Re: Oconee Nuclear Station
Docket Nos. 50-269, -270, -287

In response to the March 31, 1975 letter from Mr. Karl R. Goller, Duke Power Company submits the following proposed Technical Specification changes for the Oconee Nuclear Station.

The proposed revisions apply to Specifications 3.1.3.5, 3.5.2.3, and 3.5.2.5. The revision to Specification 3.1.3.5 incorporates an additional restriction on the regulating control rod positions prior to criticality to assure that the ejected rod worth does not exceed the 1.0% $\Delta k/k$ limit at hot zero power. The revision to Specification 3.5.2.3 deletes the specification on inserted control rod worths but at the same time specifies the manner in which the inserted control rod worths are to be maintained within acceptable limits. Finally, the revision to Specification 3.5.2.5 modifies the rod withdrawal limits for Oconee Units 2 and 3 after the control rod interchange.

UNIT 2
OCONEE NUCLEAR STATION
Figure 3.5.2-1B1

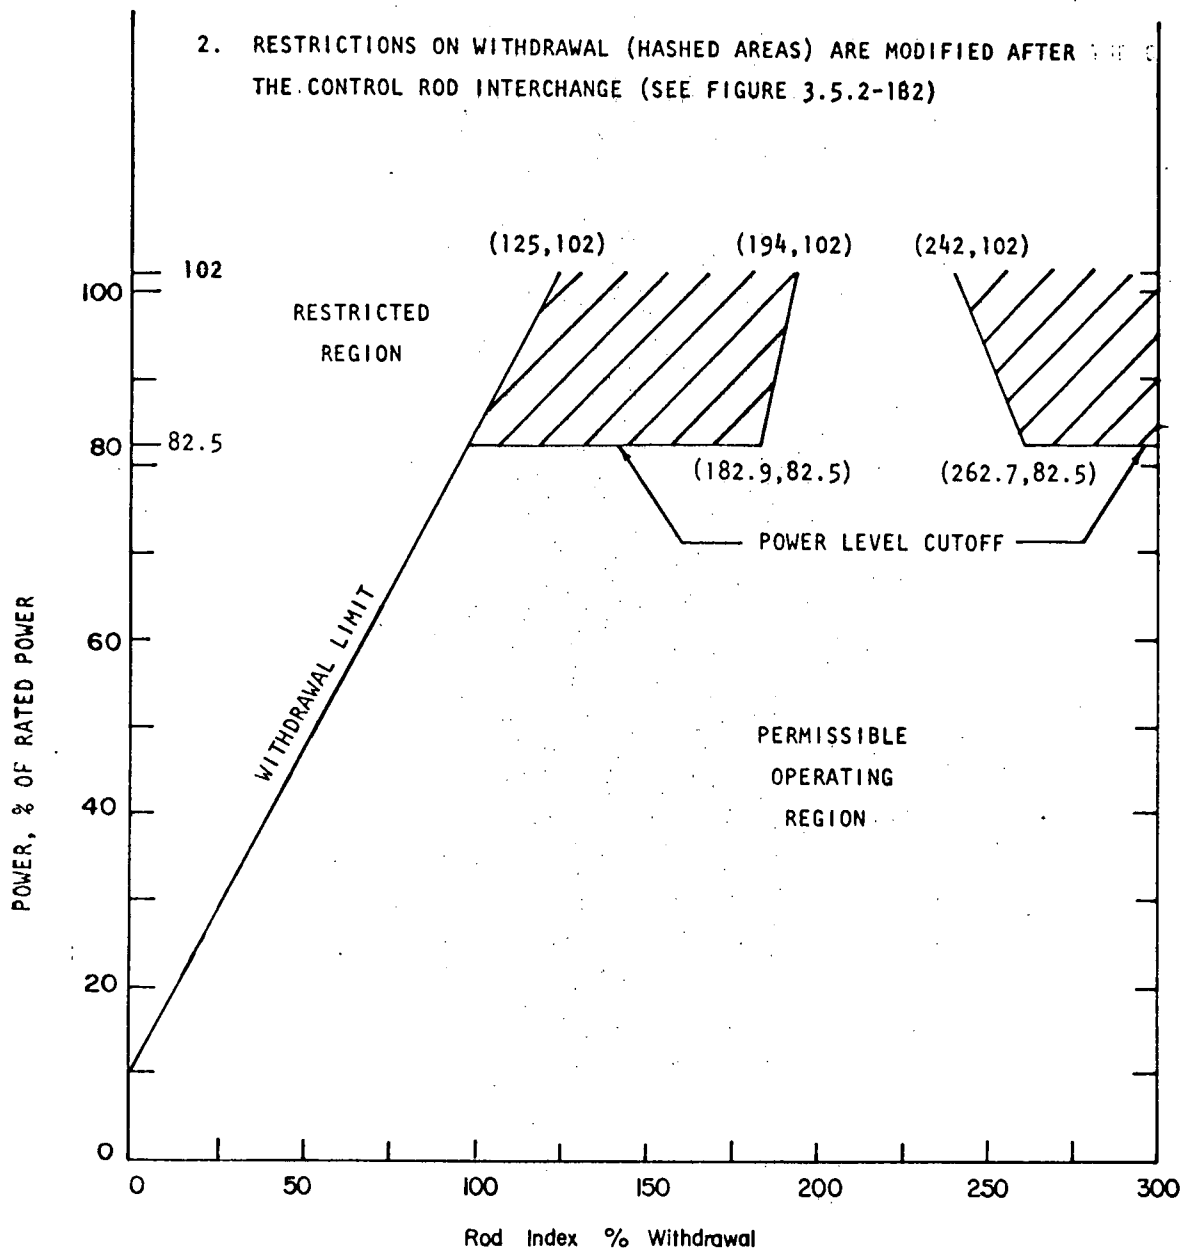
2. RESTRICTIONS ON WITHDRAWAL (HASHED AREAS) ARE MODIFIED AFTER THE CONTROL ROD INTERCHANGE (SEE FIGURE 3.5.2-1B2)

for the rod withdrawal limits specified. (An analysis of the Oconee 1, Cycle 2 ejected rod worth has been submitted to the NRC in a letter of April 14, 1975, from Mr. A. C. Thies to Mr. Norman C. Moseley, with a copy sent to Mr. Angelo Giambusso.) For Oconee 2 and 3, revised rod withdrawal limits have been proposed since the hot zero power ejected rod worths after the control rod interchange have been predicted to exceed $1\% \Delta k/k$ for certain control positions allowed by the present Specification 3.5.2.5.

UNIT 2
OCONEE NUCLEAR STATION
Figure 3.5.2-1B2

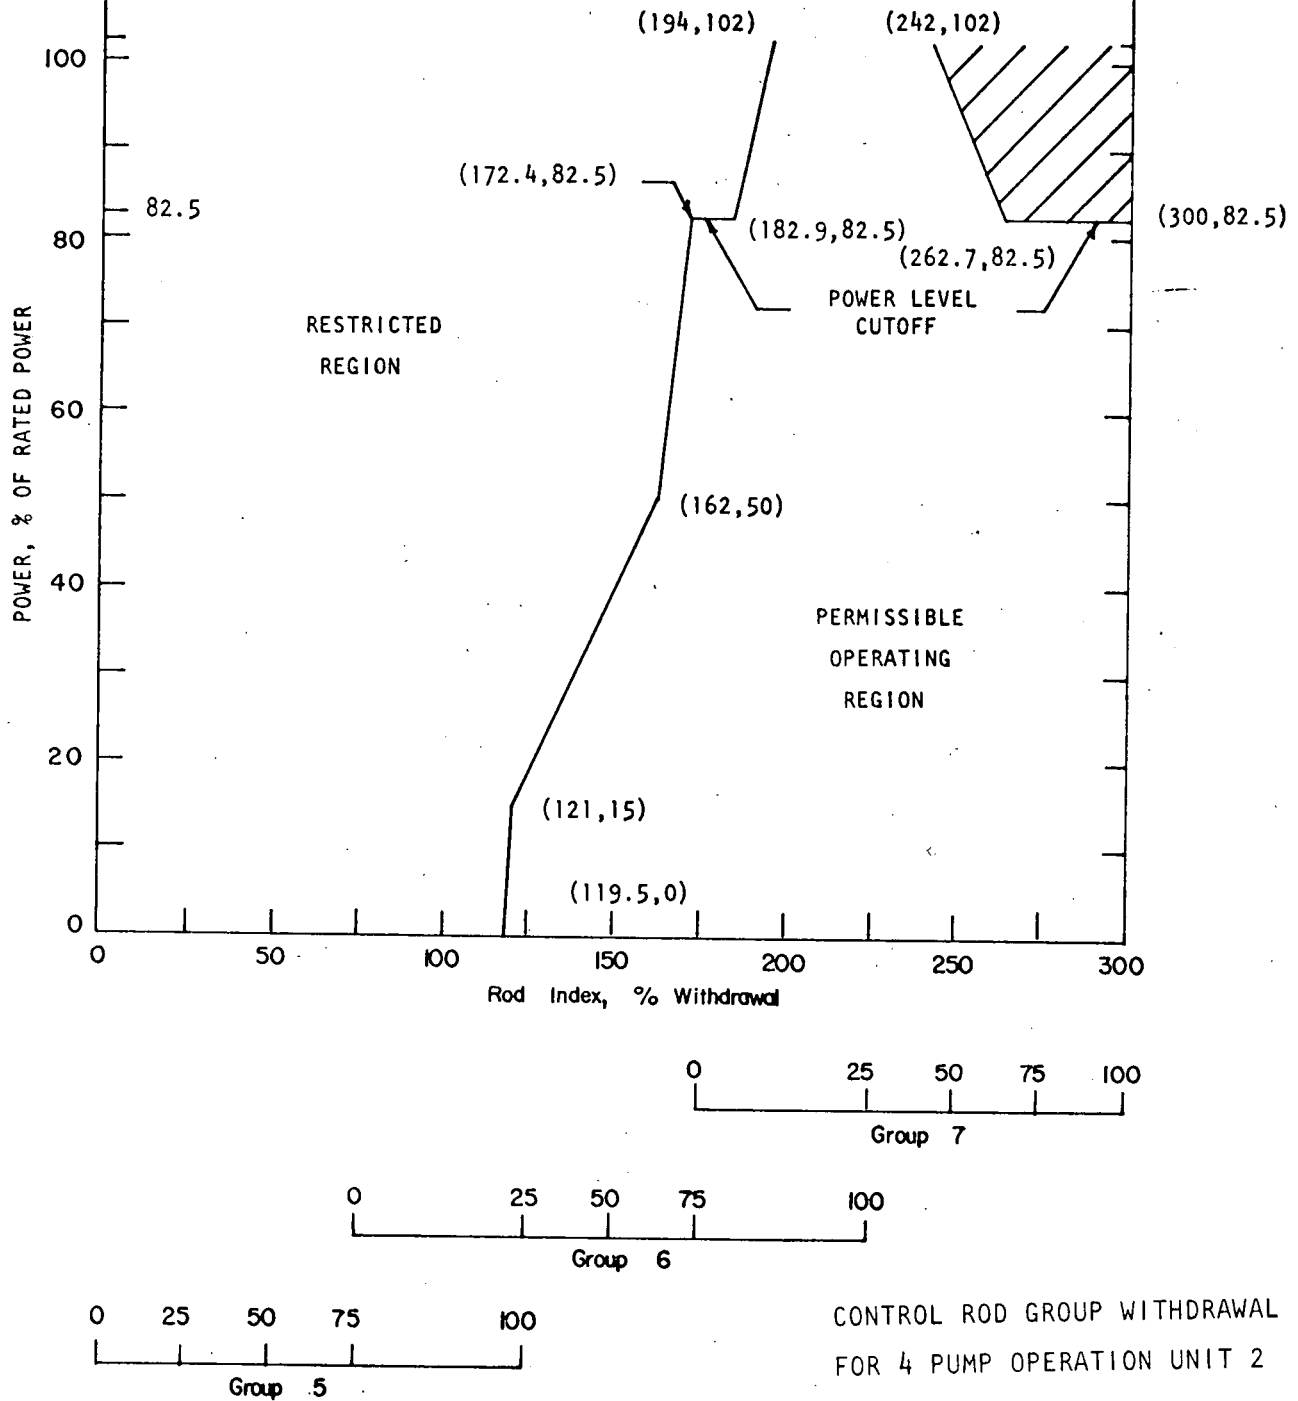
1. ROD INDEX IS THE PERCENTAGE SUM OF THE WITHDRAWAL OF THE OPERATING GROUPS.
2. THE ADDITIONAL RESTRICTIONS ON WITHDRAWAL (HASHED AREAS) ARE IN EFFECT AFTER THE CONTROL ROD INTERCHANGE. THE RESTRICTIONS ON WITHDRAWAL ARE FURTHER MODIFIED AFTER 435 FULL POWER DAYS OF OPERATION (SEE FIGURE 3.5.2-1B3)

Figure 3.5.2-1B3

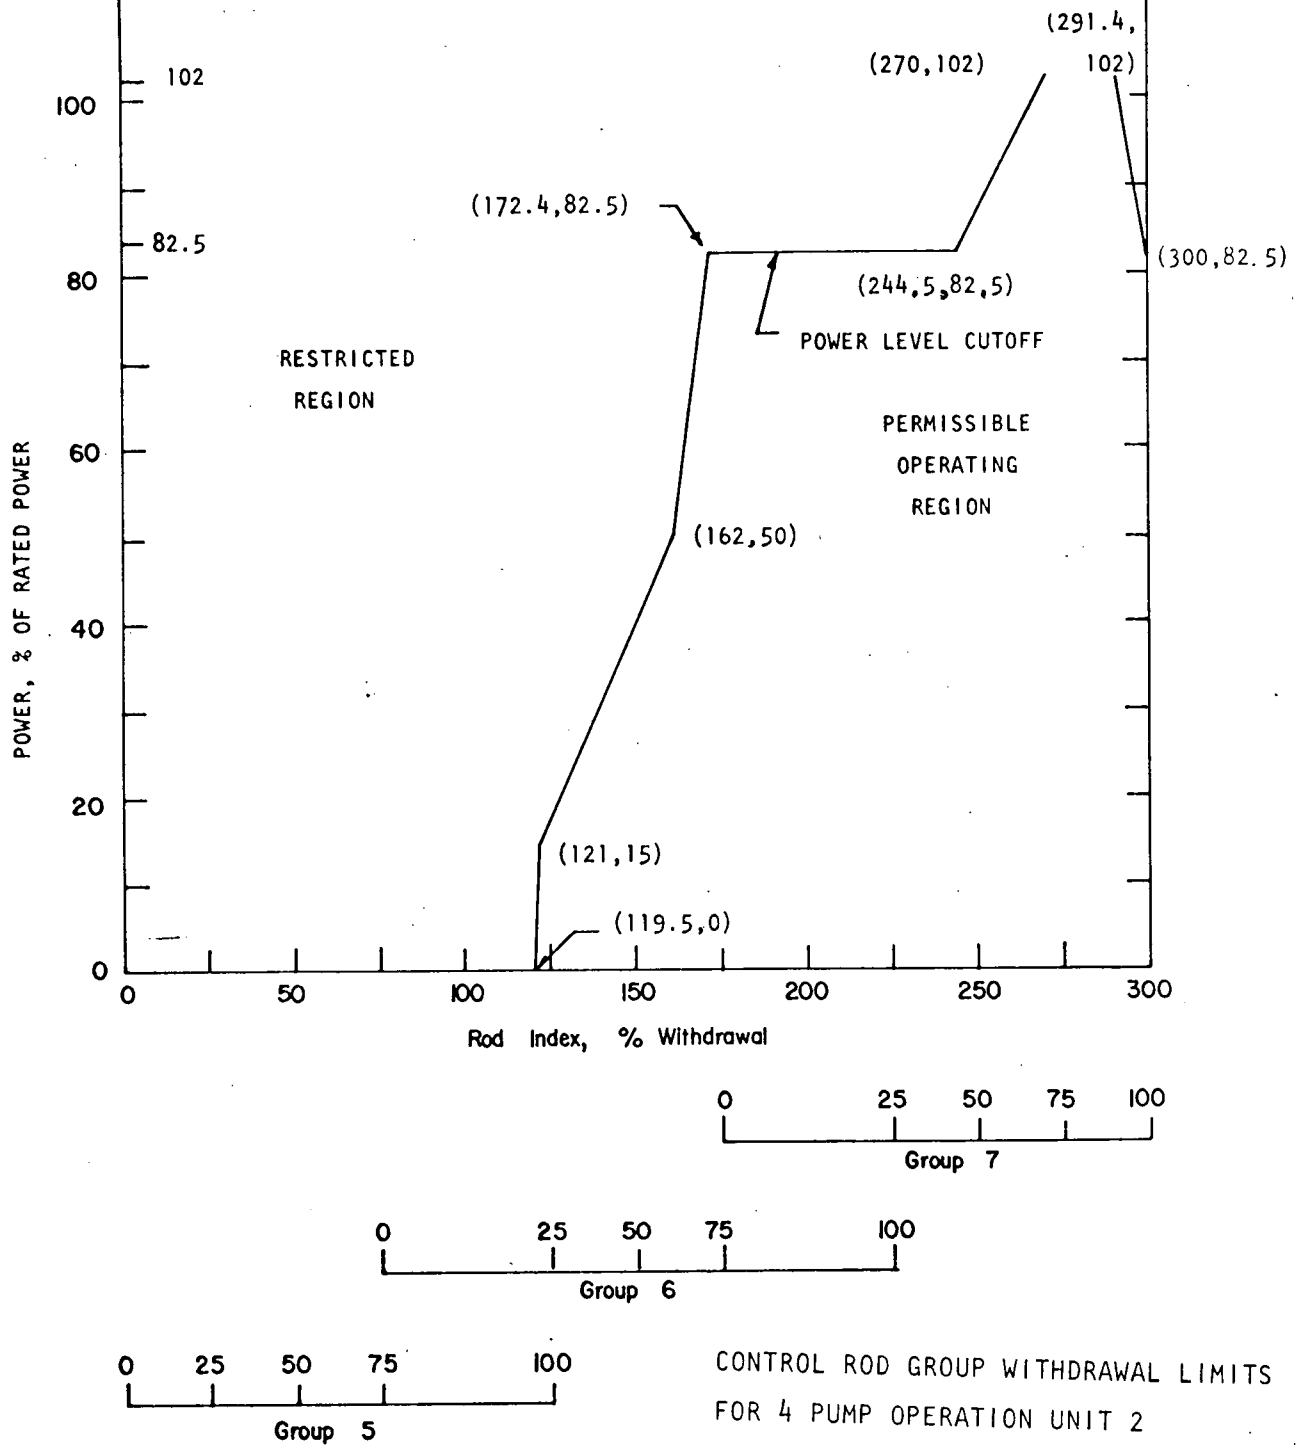
1. ROD INDEX IS THE PERCENTAGE SUM OF THE WITHDRAWAL OF THE OPERATING GROUPS.
2. THE ADDITIONAL RESTRICTIONS ON WITHDRAWAL ARE IN EFFECT AFTER 435 FULL POWER DAYS OF OPERATION.

UNIT 3
OCONEE NUCLEAR STATION
Figure 3.5.2-1C2

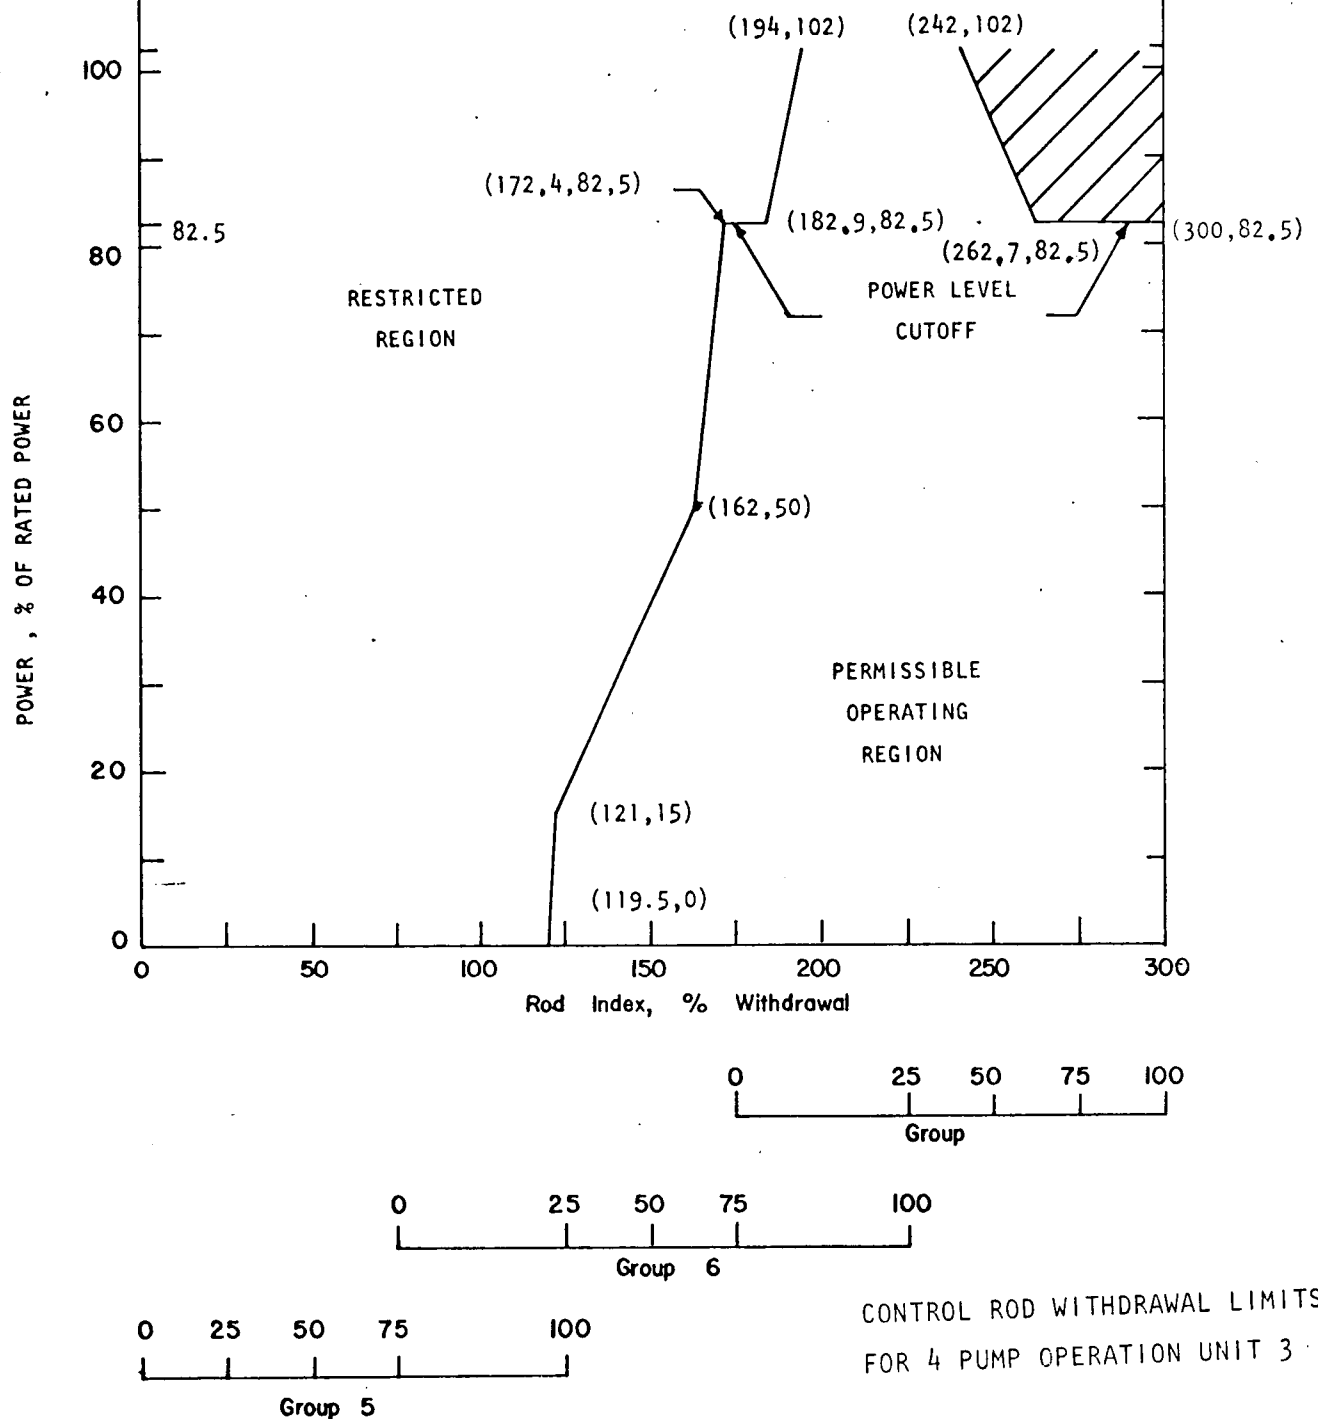
1. ROD INDEX IS THE PERCENTAGE SUM OF THE WITHDRAWAL OF THE OPERATING GROUPS.
2. THE ADDITIONAL RESTRICTIONS ON WITHDRAWAL (HASHED AREAS) ARE IN EFFECT AFTER THE CONTROL ROD INTERCHANGE. THE RESTRICTIONS ON WITHDRAWAL ARE FURTHER MODIFIED AFTER 435 FULL POWER DAYS OF OPERATION. (SEE FIGURE 3.5.2-1C3)

UNIT 3
OCONEE NUCLEAR STATION
Figure 3.5.2-103

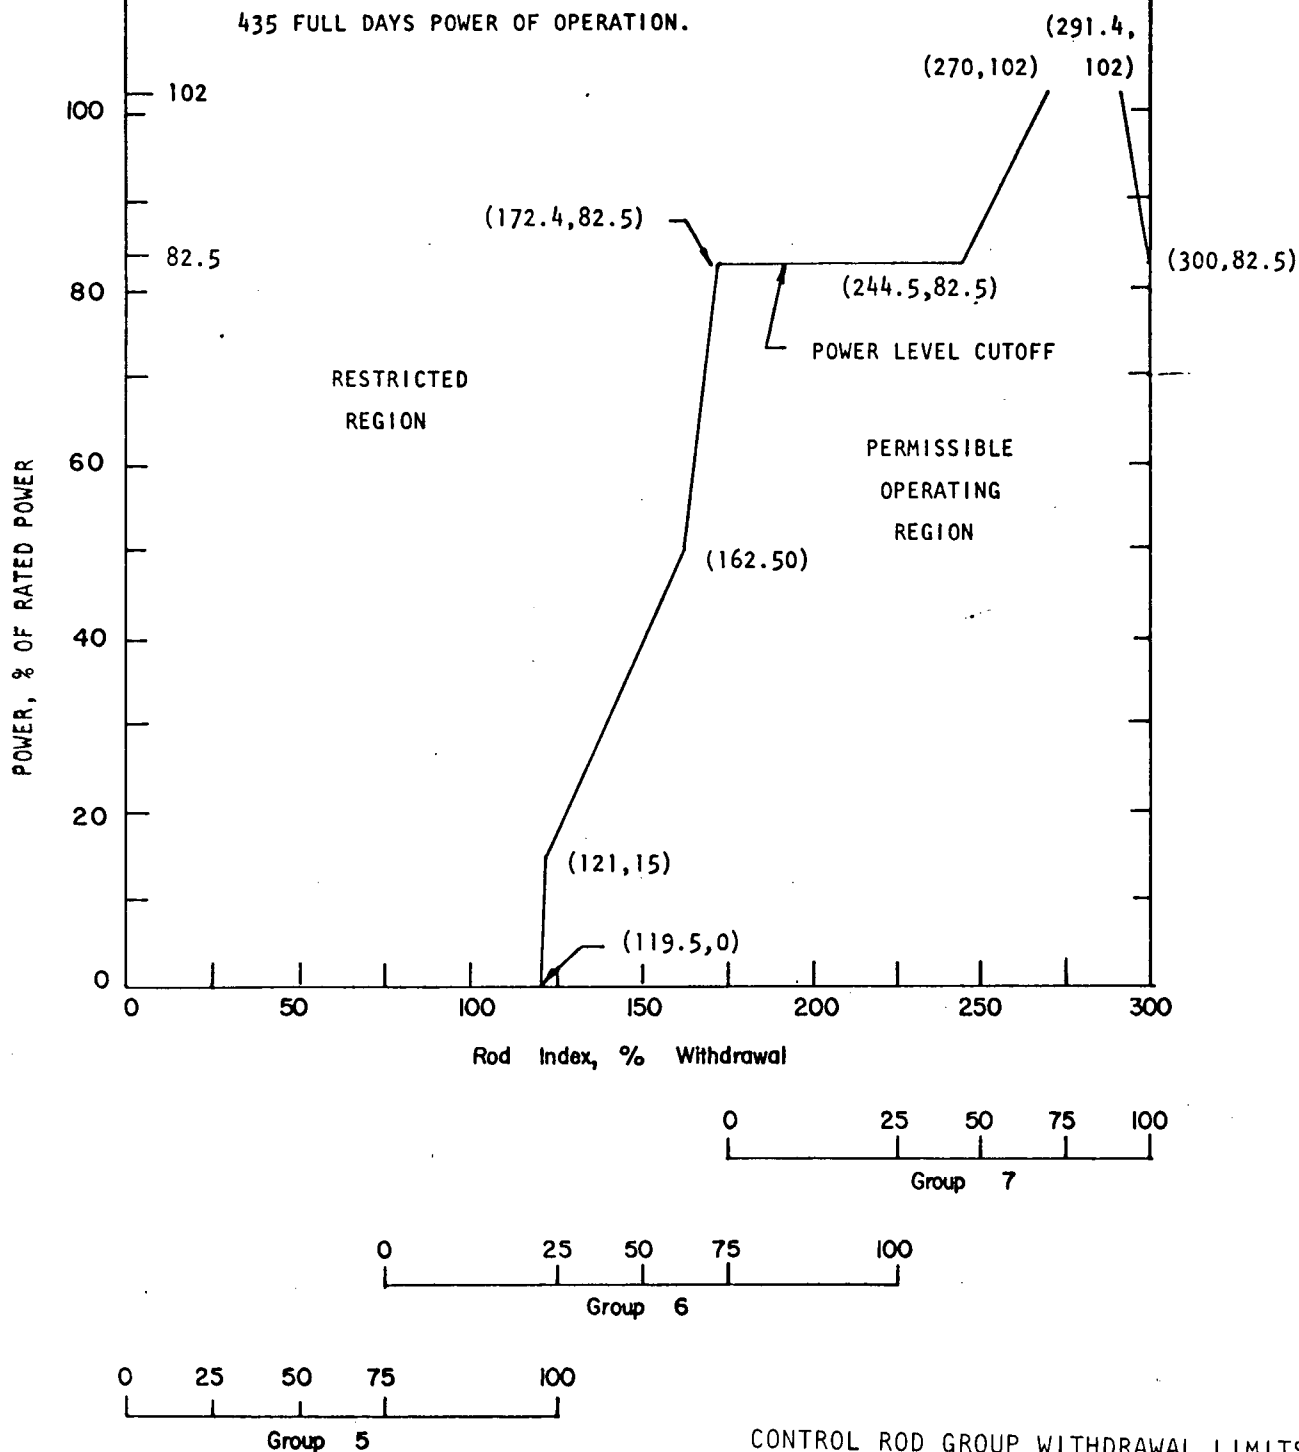
1. ROD INDEX IS THE PERCENTAGE SUM OF THE WITHDRAWAL OF THE OPERATING GROUPS.
2. THE ADDITIONAL RESTRICTIONS ON WITHDRAWAL ARE IN EFFECT AFTER 435 FULL DAYS POWER OF OPERATION.
